PROJECT THEME

Voter Score Tabulation

Voting Preference Form

Project Theme Comments

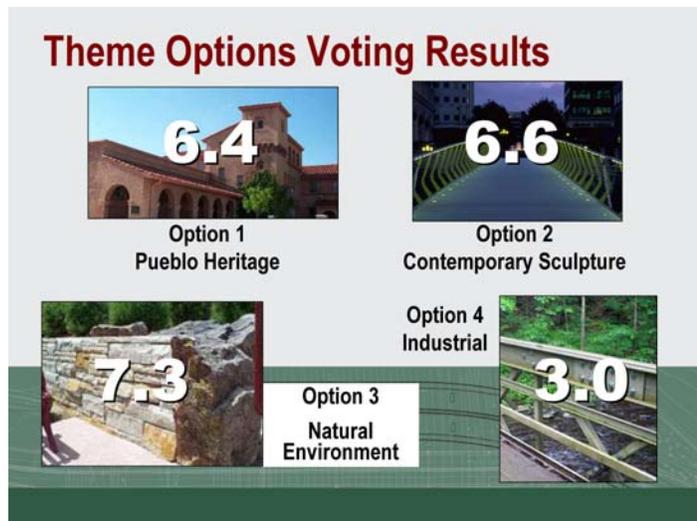
Option 1 – Pueblo Heritage

- Combination Heritage, Industrial. Industrial because steel industrial and railroad
- Needs to be somewhat incorporated, would like to see a local artist with work on bridge – ornate railing, tile

- Most agreeable for area
- Could be incorporated in “artwork” on bridge – sculpture panels, etc.
- Pueblo has a very diverse culture. If we focus on one ethnic group, the others would be left out

- I really like the arch - details use of color and materials this represents
- Combination of 1, 2 and 3 would be ideal
- I like the mission style that incorporates arches, etc.

- Celebrate the international boundary. I think the piers need to reflect Pueblo Heritage, which is masonry. This needs to be on roadway level.
- Should have southwestern style accents

- Possibly combine Option 1 & 2
- Could overlap some of the historic elements in use of natural materials on western abutment
- Multi-cultural but don’t overdo it. Art-deco and early auto. Blend with Harp.

Option 2 – Contemporary Sculpture

- Focus / impact / vertical / color
- Would like to see a combo of Contemporary and Natural theme
- Vertical impact
- Simple, clean lines. Solid looking and color
- Will be hard to accomplish with ugly river levee
- Use a combination of Concrete, Natural Stone and Steel with sweeping lines
- I like the simple lines combined with Natural Environment
- Like Harp, like design
- Perhaps the superstructure could incorporate both Option 1 and Option 2 (a more “modern” Pueblo heritage)
- The bridge deck will be contemporary but need to be supported by column, natural or heritage
- Bridge design is already modern enough
- I like the idea that a contemporary theme is less likely to be out-dated in 15-20 years
- Although this bridge is in an industrial area, that should not be the theme. I think clean efficient lines to contrast are required.
- Simplistic lines, not neon or ultra modern elements

Option 3 – Natural Environment

- With contemporary concepts included throughout
- Detail at pedestrian level
- Like the dry stack walls, rough stone
- Match new theme in HARP
- Design to stand out from the rail yards
- I would like to see a theme like the HARP bridges. That could eventually tie downtown to HARP
- Want to see use of natural materials – especially stone – works w/bluff, river environment
- I'd like to see this theme used below along the river trail/Legacy. It could be applied to the trail, nearby pier and abutment
- The natural theme needs to be carried out along the river
- Tie-in at “south” abutment to river should have a mini-park with landscaped embankment. Maybe reuse old stone abutments from old bridge.
- Structure needs to compliment recreational users along the river

Option 4 - Industrial

- Pueblo should get away from this type of industry past
- Too like the steel of rail yards below
- Not downtown
- **NO**
- We are no longer a steel city
- Could see some use to reflect railroad
- It is possible to incorporate an industrial pier type in the railroad yard only, such as used on Wabasha?
- This is my least favorite. I don't agree that form follows function is only industrial. Roadway theme Pueblo Heritage, bridge section contemporary, along the river Natural Environment
- One-half (+/-) of bridge crosses rail yard. Believe it or not, trains are fascinating for many people. Also CFI's proposed steel shapes for bridges in the past.
- Already too industrial. Need something to take you to next level
- Don't believe concrete structure blends with industrial very well
- Maybe use elements blended with Heritage theme

PEDESTRIAN RAILING

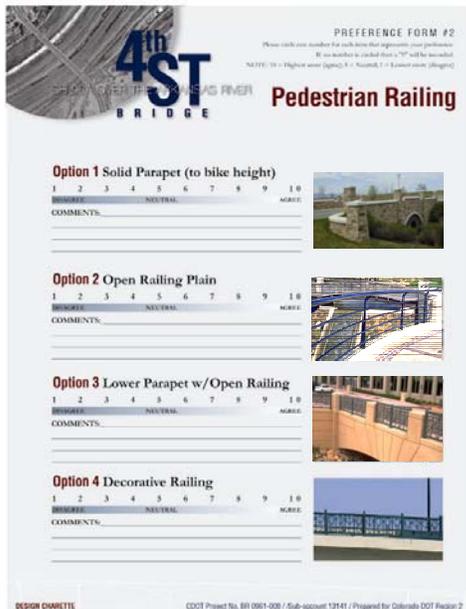
Option 1 – Solid Parapet

- Too confining
- I like the look of stone but not the solid enclosure
- People will climb on the wall or put children on top so they can see transportation and river. Graffiti problem.
- With “walls” on both side of pedestrian / bike path – too much of a confining feel – like visibility from bridge to river / rail yards – keep view for drivers as well.
- Too restrictive
- No
- Blocks view of river / rail yard.
- Adds to mass of bridge but blocks view
- I know that I like to be able to look over the bridge.

Option 2 – Open Railing - Plain

- Too plain
- Maybe add a simple decorative element (southwest design)
- I think the open railing makes the bridge look smaller and blends into the environment.
- Must not be open enough for kids to get through.
- Need rail top on Jersey barrier.
- Clean lines and southwest designs.
- There is a clear plastic panel available that could be used to meet the opening requirements yet provide visibility.
- Too plain
- Add no mass to bridge less of a comfort level
- If a Jersey style barrier is used between auto and pedestrian / bikes, we should add metal handrail for the top also to prevent bicyclists from accidentally falling into vehicular traffic.

Option 3 – Lower Parapet with Open Railing Above

- Combine open deck with security feeling of parapet. May help those with vertigo issues while still allowing benefit of open rail.
- Best of both worlds! Could work well with colors, textures on vertical elements and semi-decorative railing.
- With Option 4 – transition railing to outside of structure (side view).
- This design will look best with the Natural theme.
- I like the solid look of the parapet, but I would like to see stonework like in Option 1 instead of the stucco look in this picture.

- Looks great!!
- Open railing with vertical parapet elements spaced to accommodate lighting. Potential need for overlook areas stamped/color elements on roadside rail.
- Could be useful to increase mass of bridge.
- I like the massive balusters as a way to punctuate the open railing.
- Unique designs in both the railing and parapet.
- Established in the city on other existing bridges solid lines.
- I like this for the visibility and for the consistency with the traffic separation and median. View is important.
- I like this with decorative railing. I prefer a combination of 3 & 4.
- Have decorative pilasters periodically with inset artwork.
- Helps add mass to bridge and provide comfort, security and allows view.

Option 4 - Decorative

- Not too fancy, but works well with options
- Lower parapet with decorative open railing. Parapets with “columns” would allow for themes to be cast or inlaid on them.

- Again, simple design not to hinder viewing of elements below.
- This can be blended with Option 3.
- This looks too much like a fence with no character.

- Combine with low parapet over rail yards. “Jersey barrier” with decorative top rail also will protect pedestrians from rain, slush splashed by cars.
- Cost is an issue.

- Complement railing used for HARP but with slightly different look, i.e. art deco. Use decorative pattern on pedestrian / bike side of Jersey barrier to compliment outside rail.

- Need rail cap on Jersey barrier. Can be open with decorative top rail.
- One of a kind design or unique design – important. Provide viewing areas outside sidewalk area like Wabasha Street Bridge.

- Too busy and too expensive.
- I prefer a combination of Options 3 & 4.
- Must be bold ornate color and texture.
- Might be too “fancy” for the area the bridge is in.

- Ornate railing reflecting Pueblo’s heritage. (Like the idea of a treatment along the Jersey barrier and the viewing areas. The viewing areas need to be outside the sidewalk path.)

BRIDGE END TREATMENTS

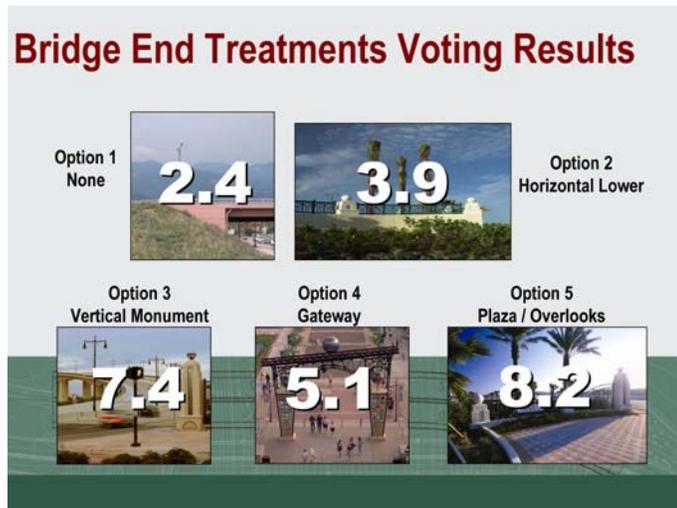
Option 1 - None

- Too plain
- Like the clean simple lines and solid colors
- Less distracting
- Terrible for the location
- Not for “signature” bridge
- Need some better sense of being on a bridge
- Erosion and weeds
- No
- Too plain

Option 2 – Horizontal Lower

- A workable solution with plaza and overlooks
- With the loop on one end and the trail/river on other high visibility excellent opportunity for southwestern natural designs
- I think this fits best with natural or contemporary theme
- May be appropriate from loop ramp roadway
- These elements could be incorporated as a regular pattern across the bridge in combination with vertical elements
- Horizontal enough
- I’m afraid this would increase the horizontal element

Option 3 – Vertical Monument

- Nice way to accent the bridge for better exposure
- Include as part of the lighting
- Possibly incorporate sculptures
- Don’t overdo what’s already been done
- Incorporate vertical elements into gateway design with overlooks. Mid-span vertical element at boundary demonstration (i.e. over pier in RR by levy) associated with viewing overlook
- Doesn’t really fit with surroundings
- Depends on type of vertical monument, i.e. see project theme and if will be timeless or dated in several years
- Something added to mark beginning and end of bridge. Needs to be noticeable from a distance.
- Given the grade on the bridge, I do not see a vertical element as an enhancement.

- Simple monument (bridge history) at north abutment – maybe small plaza that utilizes parking areas of mall
- Incorporate abutment theme across the bridge
- Not too large
- Monuments at abutments and repeated with tall vertical light weight feature at each pier, highest in center
- Keep it simple and not too massive, one at each end might be good. Combine with one plaza at each end. Use smaller versions together with decorative rail?

Option 4 - Gateway

- This would be more inviting to foot traffic if placed over the sidewalks
- Could be different at each end
- Too fussy support between walk and road not easy to handle
- Good opportunity to incorporate thematic elements
- Not sure how gateway elements would impact view westbound into town
- Incorporate into monuments emphasize the vertical
- May be too much. Not sure about mid-town end and how that might work

Option 5 – Plaza / Overlooks

- A nice overlook toward center of bridge would be a big plus
- I prefer vertical monuments combined with overlooks at scenic locations (river)
- Overlooks on the bridge as this will enhance the Legacy project

- I would like to see a plaza at both ends and overlooks on each pier
- Overlooks/plaza should be outside the sidewalk and at both ends and at least two per side on the structure. Incorporate landscaping at end plazas.

- Yes! Plaza in middle for view of rail yard and river. Shade would be great!
- Great for watching the river and trains.
- Overlook at ends and are to see river and rail – if plaza can be connected to trail system by river

- Area and west end will be excellent for overview
- Too cluttered and distracting
- These are a must because of kayak viewing and railroad viewing. Four plazas – one on each corner of bridge and two overlook over levy pier

- Overlooks at piers by plaza / parking area / trail head and south abutment
- Plaza at west abutment with possible connection to River Trail, overlooks at piers (larger ones over the river)

- Resting point in middle of bridge benches or low “wall” to sit on.
- Overlook only at ends of structure. Do not make a picnic area on the structure. West end plaza provides access to trail.

- Vertical monuments with overlooks at the abutments and mid-span. No plaza

- Overlooks would be nice over the river (best views from the bridge). A plaza just off the bridge on the SW corner would make for a nice trail head/resting spot for trail users. Don't construct plazas or overlooks where the views are poor (east end of bridge).
- Overlook at mid bridge and at bluff end, rest area for seniors/others
- One plaza at west end. Use overlooks – maybe one big or a couple of smaller ones. Have benches.

COLOR

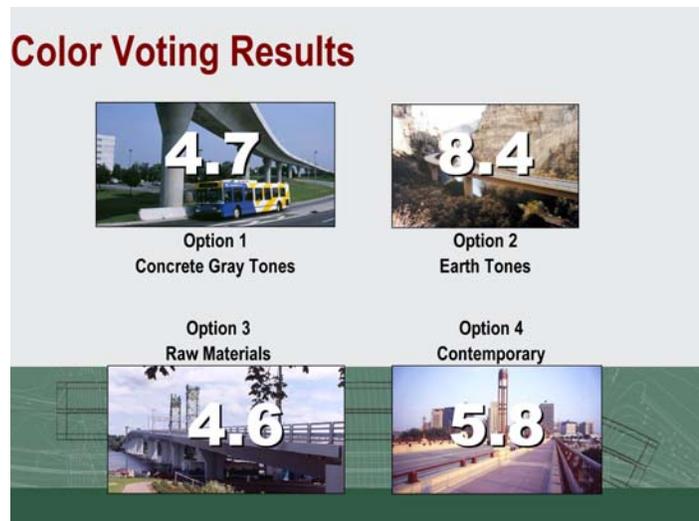
Option 1 – Concrete Gray Tones

- Too plain
- Only on piers in RR yard
- Only on structural elements, piers, boxes, deck. Use earth on parapets
- Combo of gray tones and earth tones
- For structure / piers dark gray
- For long-term maintenance, natural concrete would be best
- Use for superstructure and piers long-term color that won't fade in varying degrees, no maintenance costs
- Use earth tones or raw materials as highlights on bridge rail lighting, etc.

Option 2 – Earth Tones

- With a brighter color on railings, pier centers, etc.
- I would like the structure to be a light beige with some red highlights, i.e. railings
- Match colors on HARP and Main St. bridges

- Like Wabasha concept
- May want to keep all the newer bridges in same color palates. A lot of features in this area do revolve around the earth tones.

- With raw materials for railings, light poles, etc.
- Earth tone with contemporary highlights
- Only on top elements as related to pedestrians
- Use earth tones for major parts and eye catching contemporary colors for highlights. Can be bridge colors but limited, i.e. bridge hand rails

- Paint select areas of the bridge use “natural” concrete colors on the rest of the bridge
- For features please stay away from the Pueblo “tan”
- Earth tones that are not too dark go with most every color scheme

- Perhaps compliment with contemporary colors for the west abutment to blend with reviver trail/natural setting
- Use as accents for gray tones. Use lighter tones. Darker ones fade in high UV light.

Option 3 – Raw Materials

- Too plain
- On predominately sun-shaded areas (bottom of box girder, etc.)
- Understructure of bridge – dark grays to hide smoke discoloration from locomotives to emphasize shadows

- Railings, light poles, etc. Bridge concrete to be earth tones
- Blends in too much
- Tone could go well with area, i.e. rail yard etc.
- Too dark
- Seem to dark / harsh
- These colors appear too dark and lifeless
- Could be used for accents

Option 4 - Contemporary

- Only for accents
- I would like to use the Pueblo sun logo on the sidewalk in the overlook areas
- Accents
- At monuments / overlooks
- Use sparingly to accent only
- Especially for accents – like railings, handrails, etc. Wabasha concept is good
- Don't want to go too crazy with too much loud color. Some louder color for a "punch" might be nice
- Focal color w/earth tones base
- Will be hard to match and maintain in later years
- Okay, but not the primary colors
- I think some bridge accent colors would be good
- Accent colors for railings, vertical elements and abutments
- Too bright. "Racing stripes" over used. Stay away from colors that are associated with heat. Pueblo is already too warm.

DECK LIGHTING

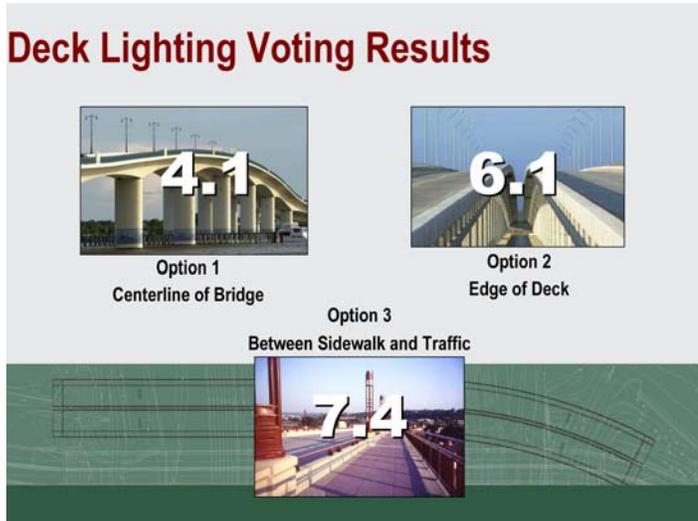
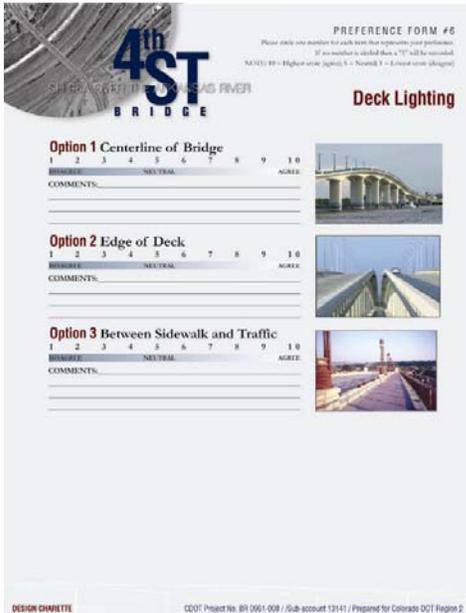
Option 1 – Centerline of Bridge

- For deck lighting
- Don't like this option because of the 6' separation
- This option draws your eyes to the center of the bridge, but I don't think it is inviting to pedestrians
- If we do this, we need separate pedestrian lighting between sidewalk and traffic
- Good use of lighting if it provides sidewalk lighting too
- This may not fit with lighting locations off the structure, but I have seen transitions from edge of road to centerline, like Santa Fe in Littleton

Option 2 – Edge of Deck

- For pedestrian lighting
- Minimizing maintenance and precludes vehicle hits and pedestrian vandalism
- Matches existing lights on 4th St. east and west of bridge
- OK
- Both roadway and pedestrian light. The sidewalk lighting to be low and at much closer intervals, this will enhance this night view of the bridge
- It looks too column like
- Roadway and pedestrian lights on same pole
- Design to eliminate reduction in total sidewalk width if possible
- On such a long structure, edge of deck lighting concerns me due to vibrations at mid-span. Can traffic and pedestrian lighting be separate?

Option 3 – Between Sidewalk and Traffic

- If roadway fixtures overhang the travel lanes, you can reduce the number of fixtures.
- Especially with consistent combined pedestrian / vehicular fixture
- Use light standards for flags, flowers, etc.? Don't consider high mast except for RR yard. At RR yard, can lights be more directional (shine down track) so it's not lighting the world. High mast is stark and industrial looking, so keeping it minimal to me RR needs are important.
- Opportunity to highlight the separation between vehicles/pedestrians – perhaps easier to maintain. More open feel and clean lines of outside of bridge.
- Combine poles, street light / pedestrian series of graduating heights from tallest at pier location
- I prefer a pole/fixture like the one in booklet Option 2 with high traffic light and lower pedestrian light
- I like this idea with deck and pedestrian lighting with a decorative pole

- Linear lighting on inside of pedestrian pathway
- With custom decorative lighting integrated into design of barrier and railway
- Combine 2 and 3 pedestrians between and cobras off outside
- Separates the sidewalk from roadway and sets up a usual barrier for drivers
- This option seems to preclude taking out the walk to add another traffic lane

AESTHETIC LIGHTING

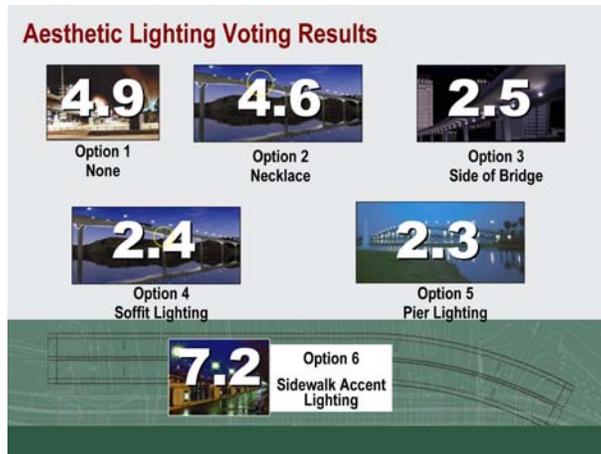
Option 1 - None

- This makes the most sense due to area lighting from other sources
- I don't think enough people will get to view the bridge, only from Union Ave. and trail users (none of which will be there at night)
- CDOT bridge inspection forces would not be available or assigned to maintain lighting (i.e. must be maintained by others)
- The overhead lighting could be used aesthetically

Option 2 – Necklace (String of Pearls)

- With Option 6
- Accessible from up top
- Using additional pedestrian lights as the “necklace”
- Accent lighting may accomplish this
- Excellent – if the lighting effect is not neutralized by RR lights
- Only if its not washed out or accomplished with pedestrian lights
- This would be a nice effect if it could be incorporated with the overhead lighting

Option 3 – Side of Bridge

- Difficult to maintain
- Option 3, 4 and 5. Who sees this? How many people actually benefit from the lights?

Option 4 – Soffit Lighting

- This would probably be most effective over the river. It may be washed out over the RR yard
- Not enough piers
- With the railroad lighting being overhead, there will still be shadows under structure allowing accent lighting
- Too high maintenance

Option 5 – Pier Lighting

- At river trail only
- On trail side pier only
- Too much light!
- Pier space is uneven – would look funny
- Too high maintenance

Option 6 – Sidewalk Accent Lighting

- With Option 2
- On roadway lighting poles
- Lights for walkway at close spacing for lighting both
- Could be more inviting for pedestrians at night. Should at least explore some ideas.
- Have lights shine both inward and out if possible
- Try to incorporate into string of pearls concept
- No low fixtures – can accomplish with pedestrian lights
- Is this a high volume pedestrian movement at night? If yes, might be nice feature; if not – who sees it?
- Linear or string lighting
- Maintenance is the biggest concern.
- This could be accomplished with the overhead lighting
